DONAGHY / VERULLA  
ADDITION PROPOSAL  
1208 WASHINGTON AVE.  
PORTLAND

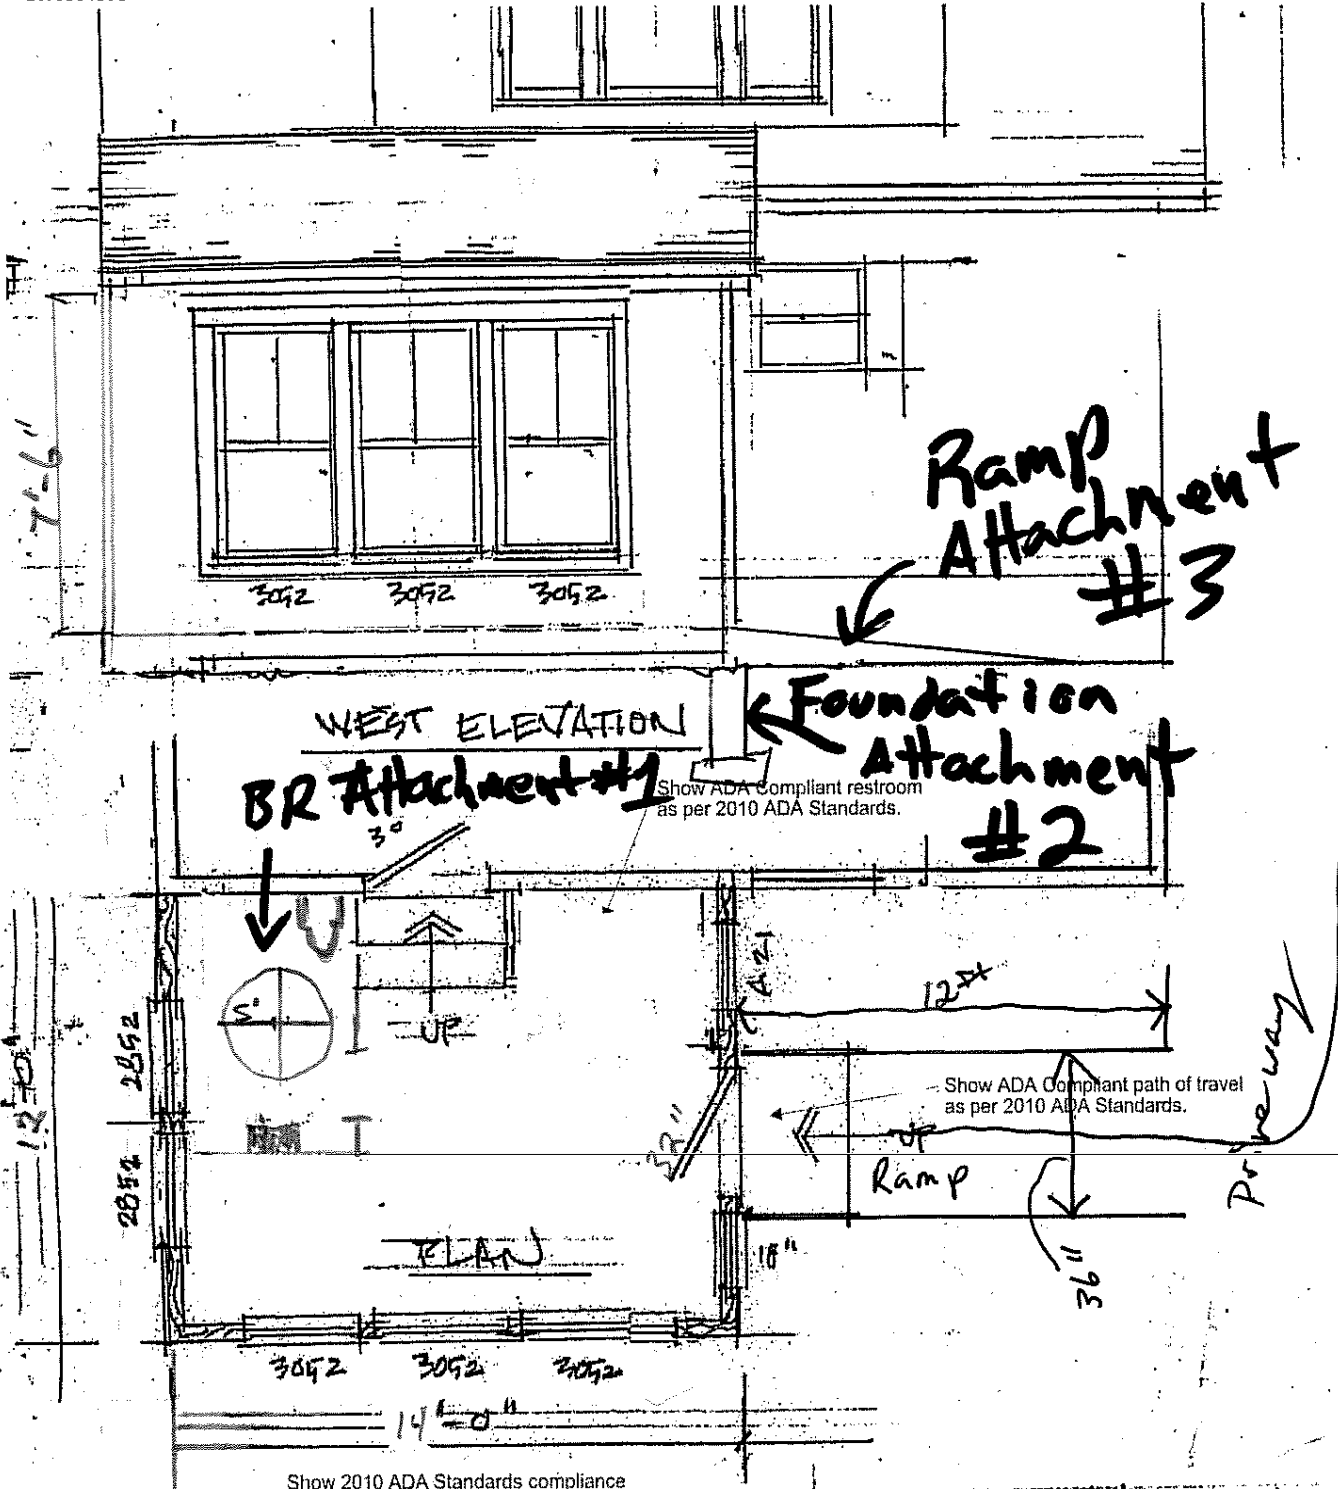
Show 2010 ADA Standards compliance with section 36.401 New Construction.

Please provide a section view drawing with the following information:  
Footing dimensions and depth below grade.  
Foundation damp proofing and drainage.  
Crawl space venting sizes/locations.  
Anchor bolt size and spacing.  
Joist, stud and rafter spacing.  
Framing connections and fastener schedule.  
Sheathing (floor, roof, wall) span ratings and thicknesses.

Please provide the following information on current drawings:  
Door/window header sizes/spans and number of jack studs.  
Insulation R-values for foundation, floor, walls and roof.  
Door/window U-values.  
Safety glazing locations.  
Stair riser and tread dimensions.  
Handrail locations and heights.
